# Little Creek Solar Project

**MODIFICATIONS DOCUMENT (REA # 3068-93AP8E)**

*NOVEMBER 2013*

**Figure 2: Little Creek Predicted Noise Level Contours at 1.5 and 4.5 m Height (Preliminary layout)**

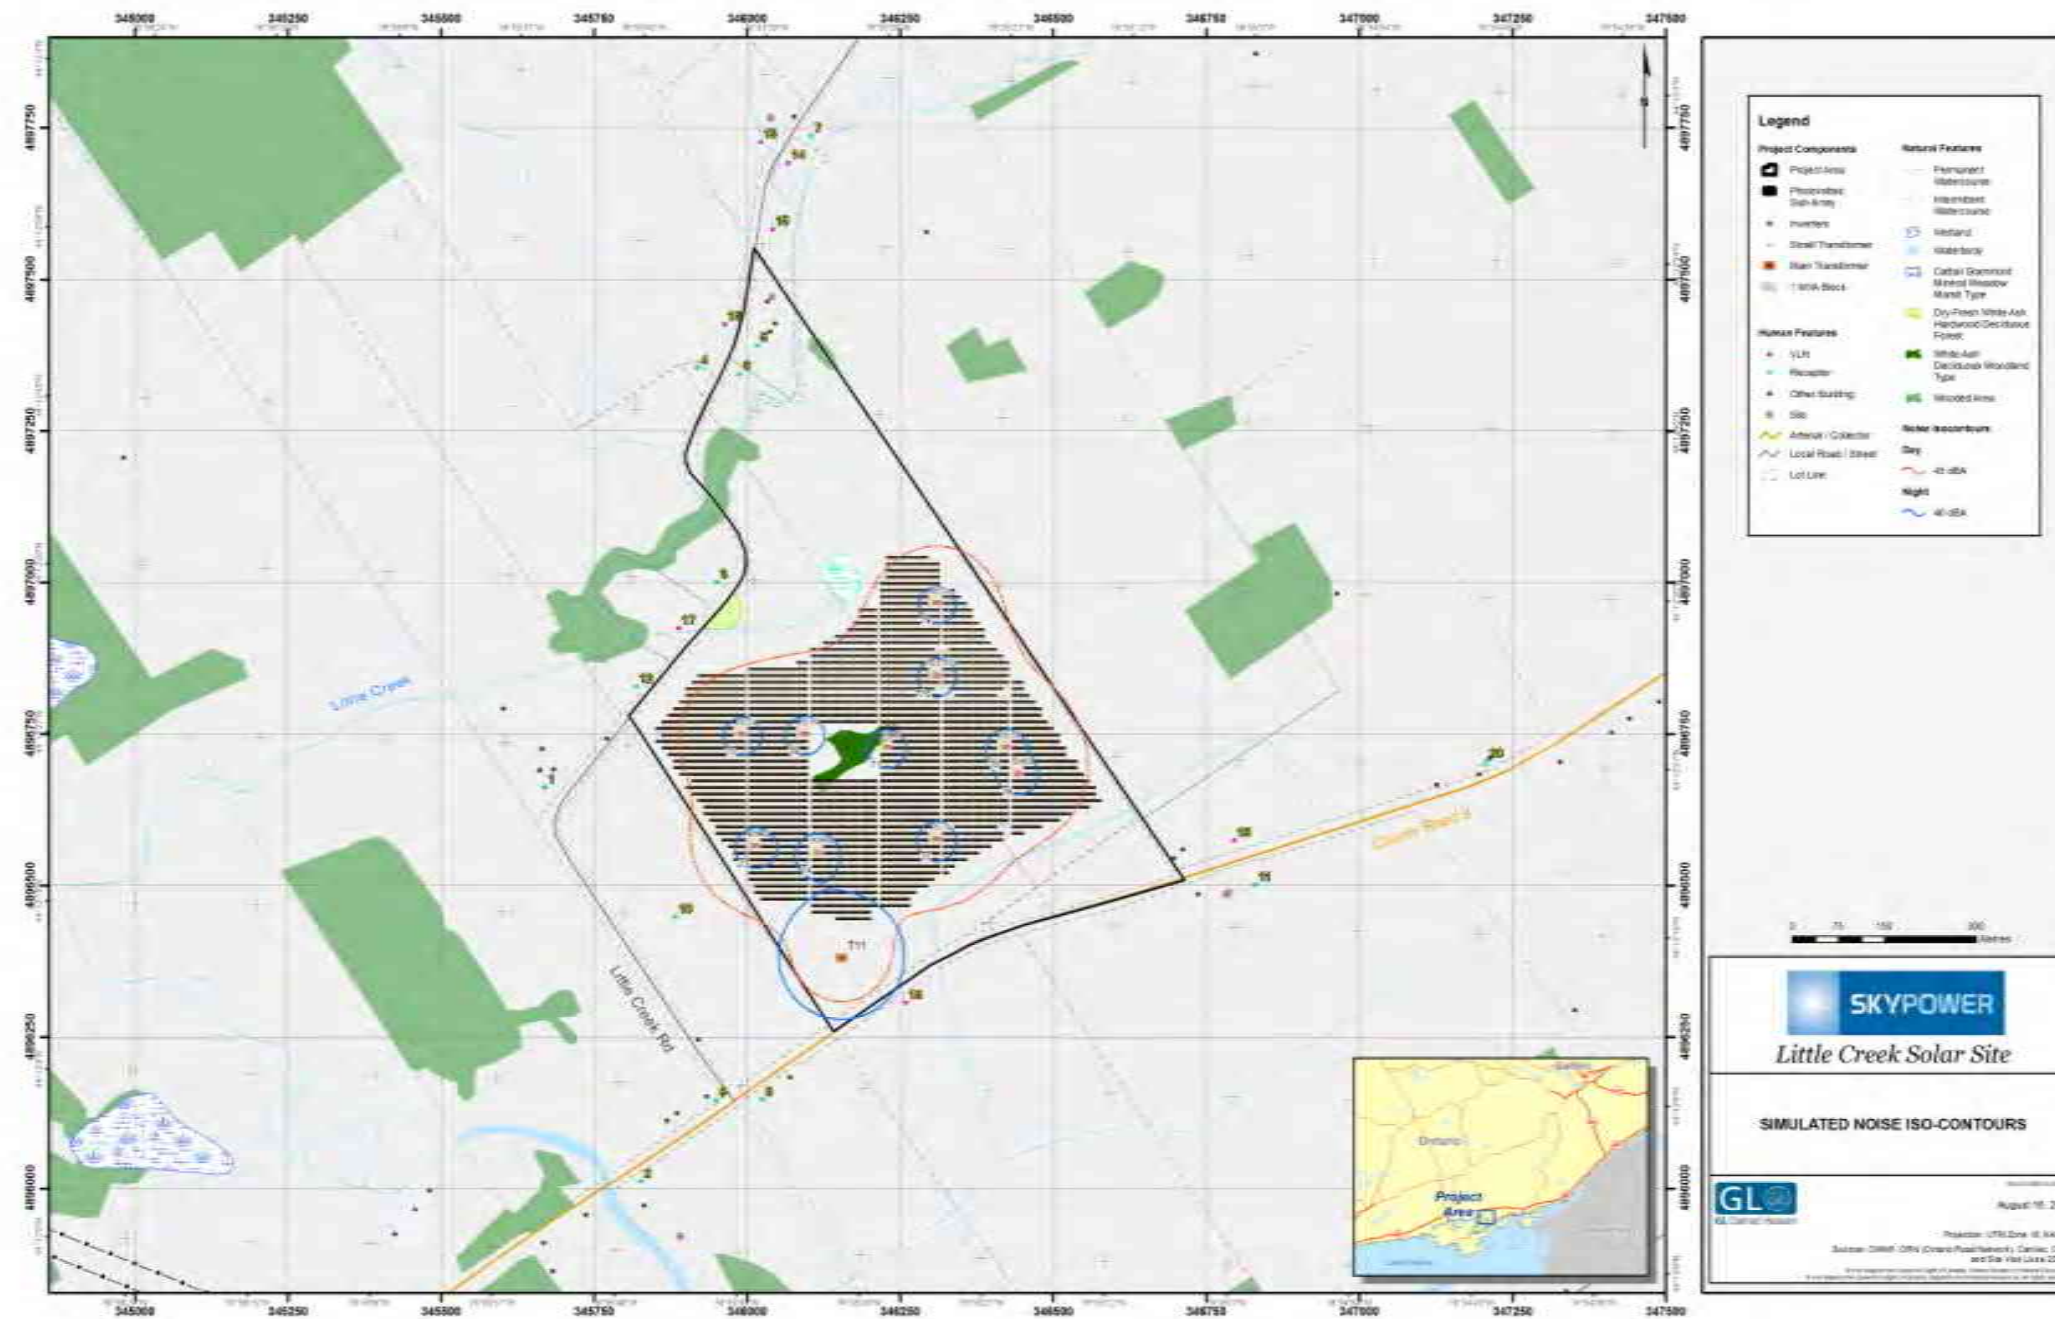
The proponent has prepared a revised *Noise Study Report*, as included in **Appendix G**, based on the technical changes discussed above. The revised *Noise Study Report* indicates that the Little Creek Solar Project will be in compliance with the MOE's noise standards provided that acoustic louvers are installed at Inverters 5 and 6. Figures from both the preliminary and revised *Noise Study Reports* that show the overall 40dBA contour footprints are provided in **Appendix C**. The complete revised *Noise Study Report* is presented in **Appendix G**.

# Little Creek Figure 4: Predicted Noise Level Contours at 1.5 m Height

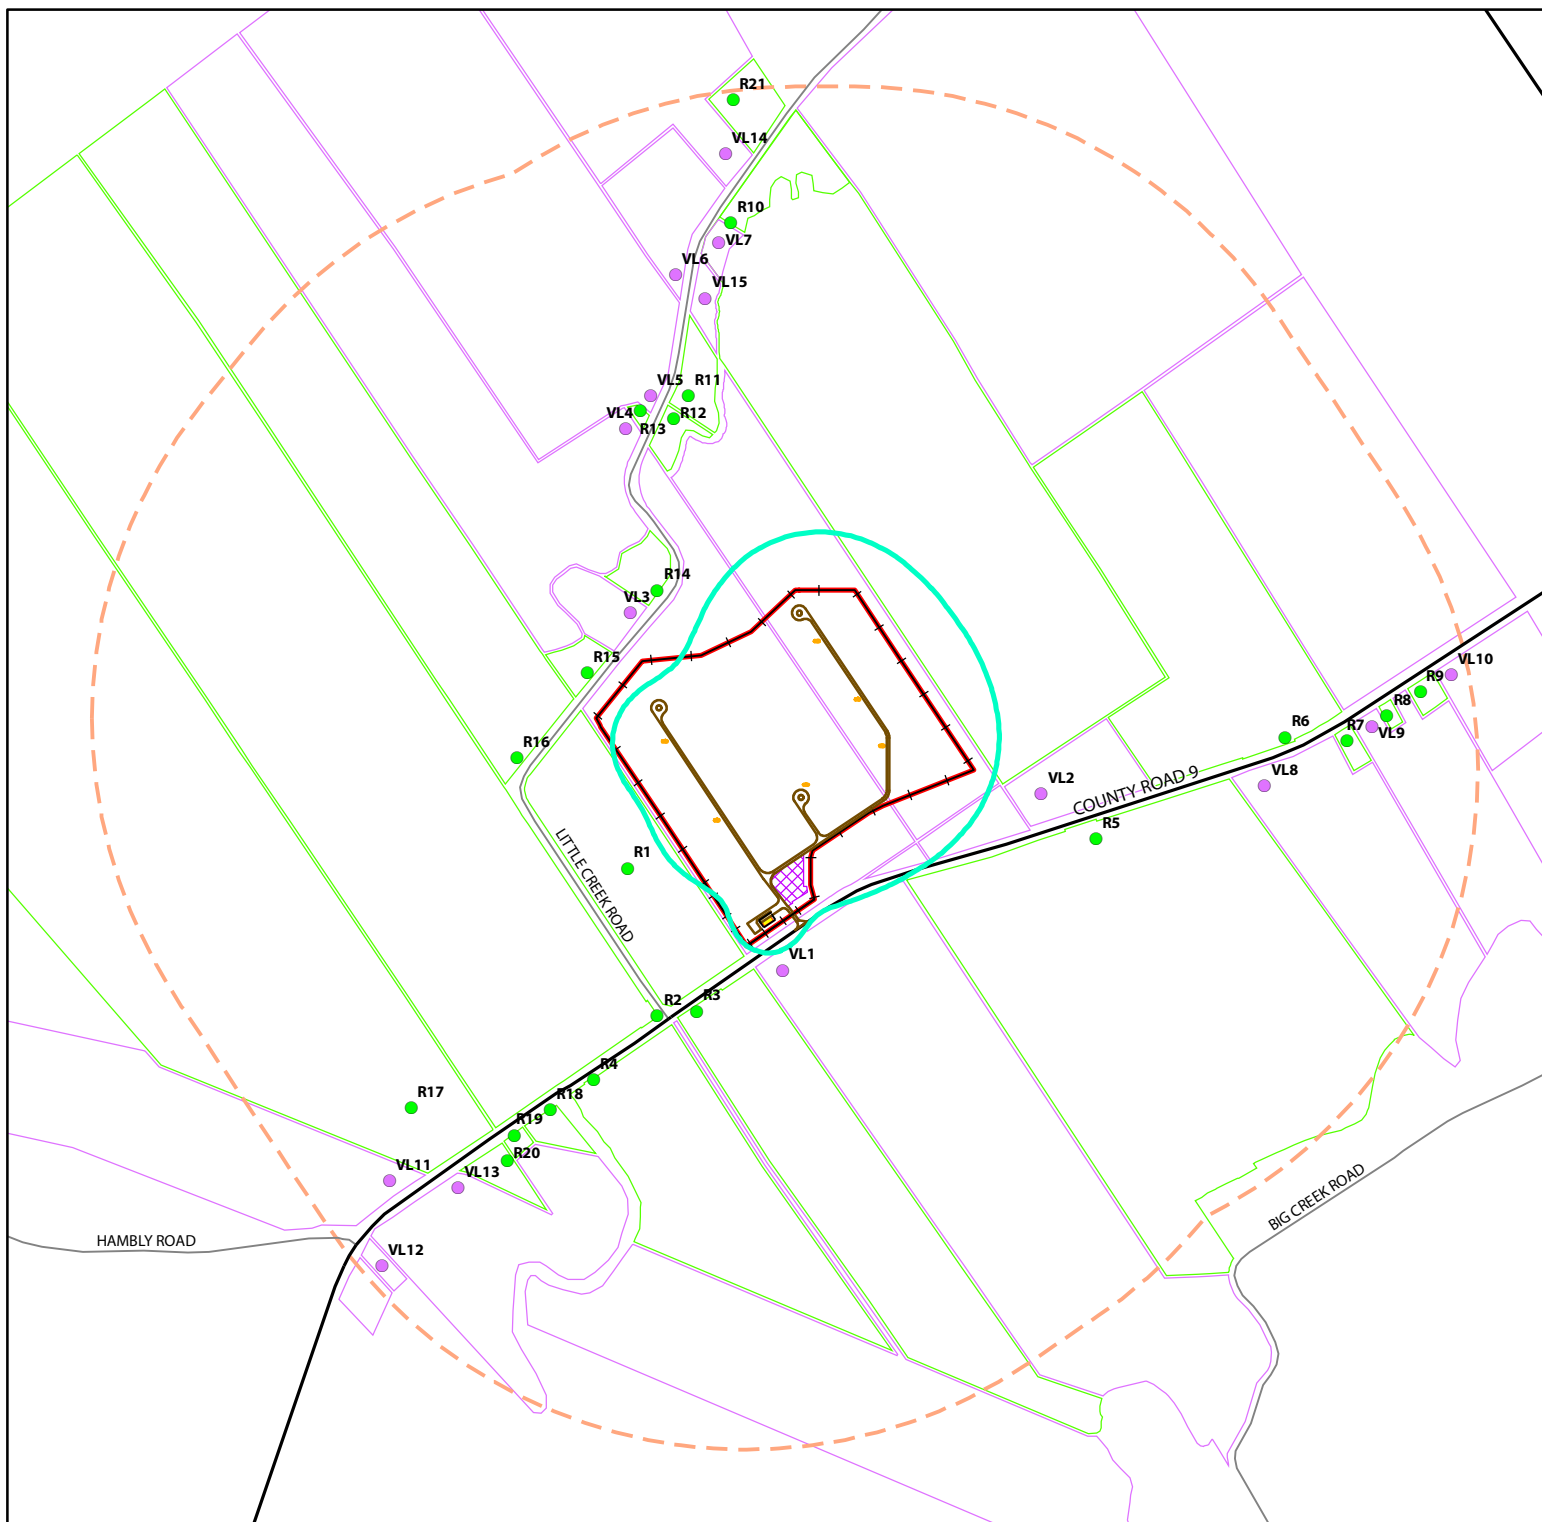
**Inverter Stations** – Each inverter station consists of two (2) inverters and one (1) 1.6 MVA step-up inverter transformer, with the exception of station #2 which will have one (1) inverter and a 0.8 MVA step-up inverter transformer. The components are expected to be operational primarily during the daytime period; however, to be conservative the contributions from these sources were also included in the nighttime scenario. As per the MOE requirement, a 5 dB tonal penalty was added to the inverter and inverter transformer noise spectrums for the tonal aspect of the noise generated by these sources. The inverter units were modeled as point sources with hemi-spherical spreading.

**Substation Transformer** – The substation transformers were modeled using calculated transformer sound power spectrum based on the NEMA (noise) rating provided by the manufacturer (see **Appendix A**). A 5 dB tonal penalty was also added to the transformer noise spectrum. Like the inverter units, the transformers were conservatively modeled using the same data for nighttime as for daytime. The transformers were modeled as point sources with hemi-spherical spreading.
